# MANDATORY SERVICE BULLETIN

## MSB 42-077

## MSB 42NG-007

Check of emergency exit lever.

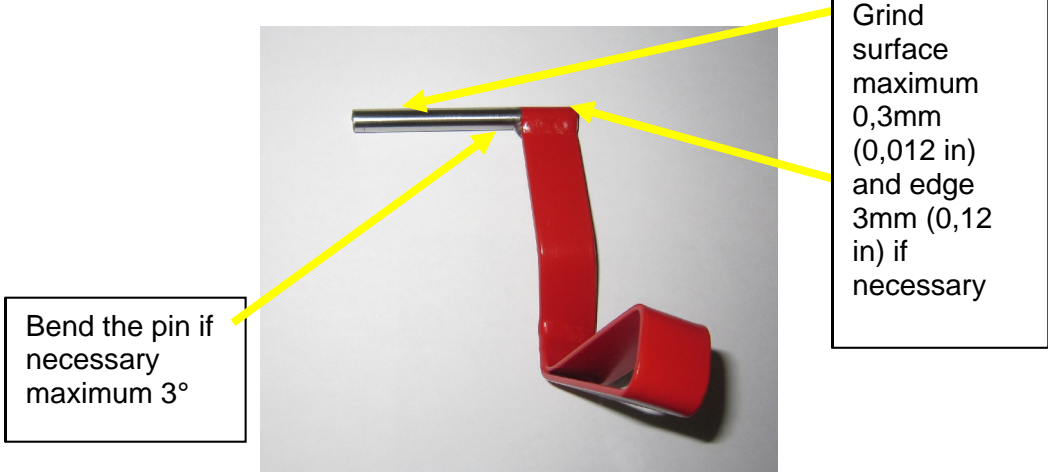
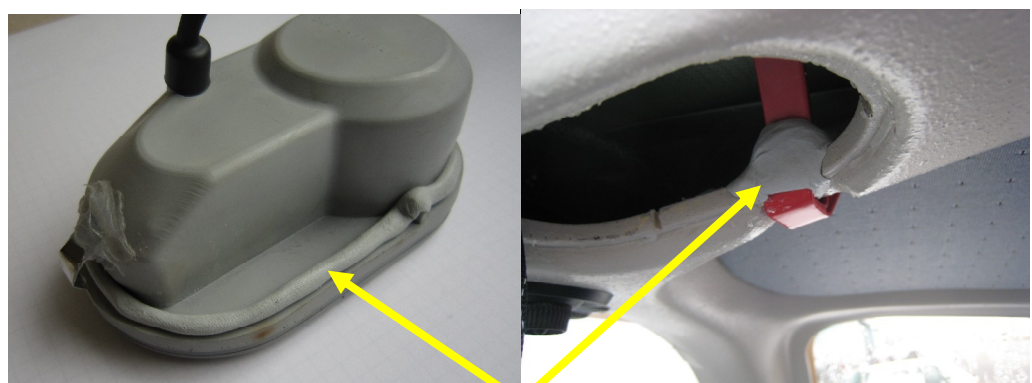
5	<p>Rework lever pin, refer to picture.</p>  <p>Bend the pin if necessary maximum 3°</p> <p>Grind surface maximum 0,3mm (0,012 in) and edge 3mm (0,12 in) if necessary</p> <p>The minimum pin diameter is 5,7mm (0.225 in).</p>
6	<p>Install the modified emergency lever and test the release with hand force. If a release is possible, reinstall the emergency exit lever.</p>
7	<p>If a release is not possible, replace the emergency exit lever with DA4-5200-71-00_1.</p>
8	<p>Seal reading light and emergency lever with Terostat IX.</p>  <p>Sealing Terostat IX</p> <p><b>CAUTION:</b> Do not use silicone or any equivalent to seal the gap.</p>
